Before the Caldwell Planning and Zoning Commission
City of Caldwell, Idaho
Public Hearing Held August 11, 2020

Subject: **Case No. CMP-20-04/ZON 20 05/SUB-20P-05 (AeroSky Park Subdivision)**
Parcel: R35305

2.6 ENGINEERING Memorandum Comments (Exhibit PA-1)

EXHIBIT "A14"
AEROSKY PARK SUBDIVISION PRELIMINARY PLAT(revised)

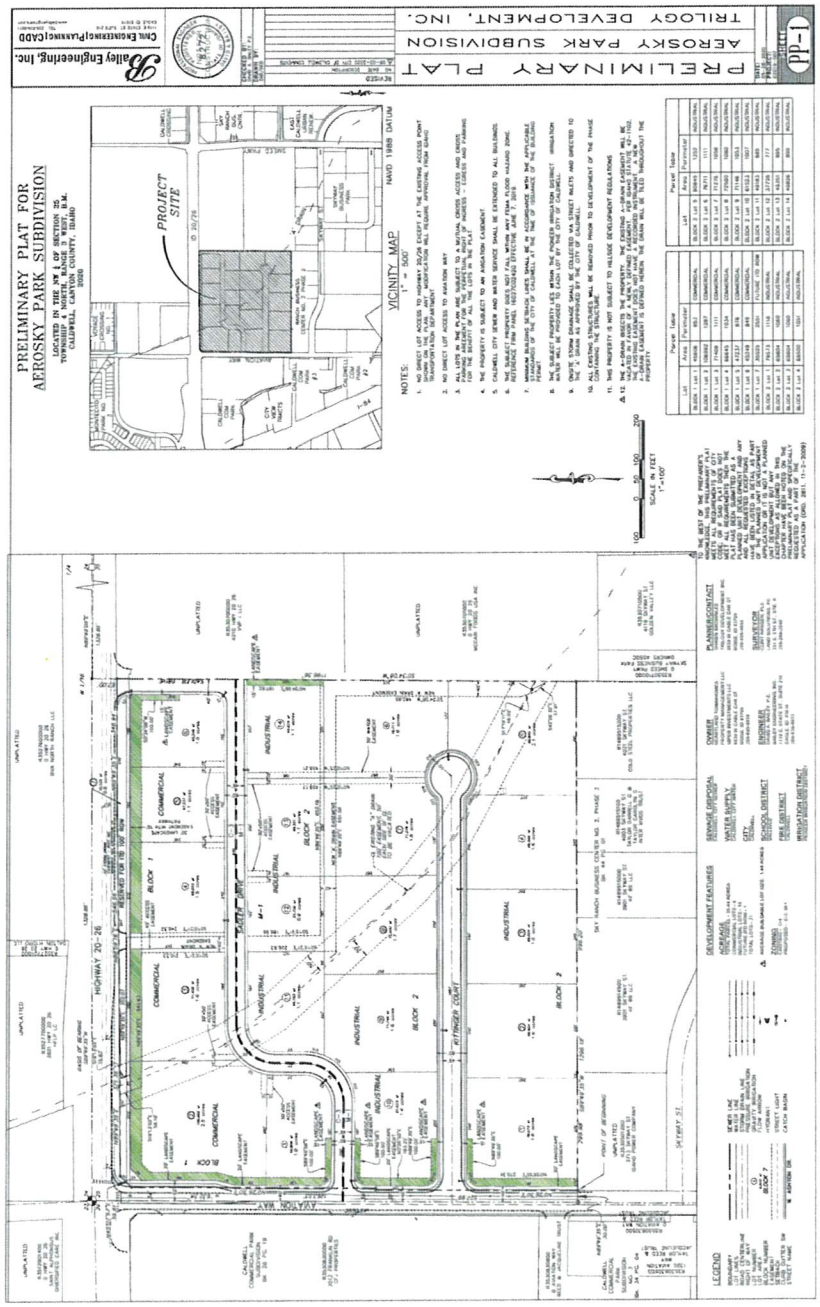
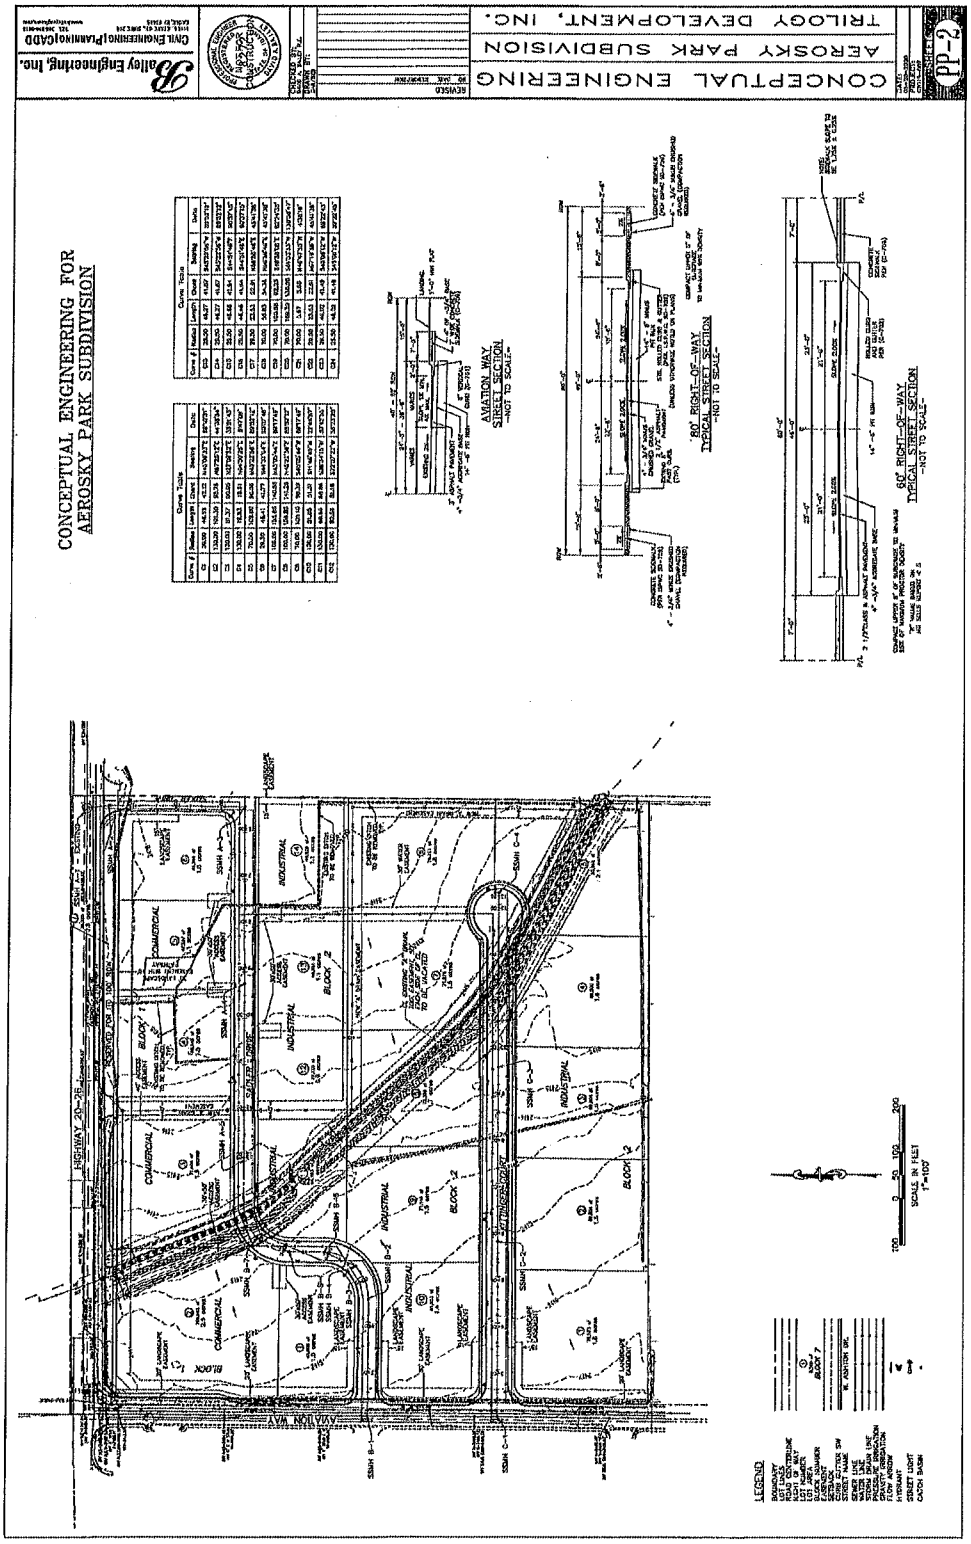
4. A Northbound right hand turn lane will be required at the intersection of Aviation and Highway 20/26 per City Detail R-810 G.

1. All on site water mains will need to be looped into existing mains for fire flow and water quality purposes. Internal main sizing and construction plan approval, will be dependent upon the availability of fire flow.

2. Sewer is available from a 12-inch line in Aviation Way. The location of sewer service, including sizing of mains, providing of easements, frontage construction, and offsite construction are to be decided during review of improvement plans. This development will be required to comply with the Franklin Sewer Study as updated.

1. The Preliminary Plat shows the A-Drain running through the subdivision. the A-Drain is owned and operated by the City of Caldwell. A-Drain tiling plans will need to be reviewed and approved before any construction work may commence. Existing easements and/or right-of-ways for this facility and any other irrigation facility shall be determined and clearly indicated on the construction plans and on the final plat (excluding prescriptive easements). Construction across or re-routing of these facilities is subject to approval by the City and must be clearly delineated on the constuction drawings.
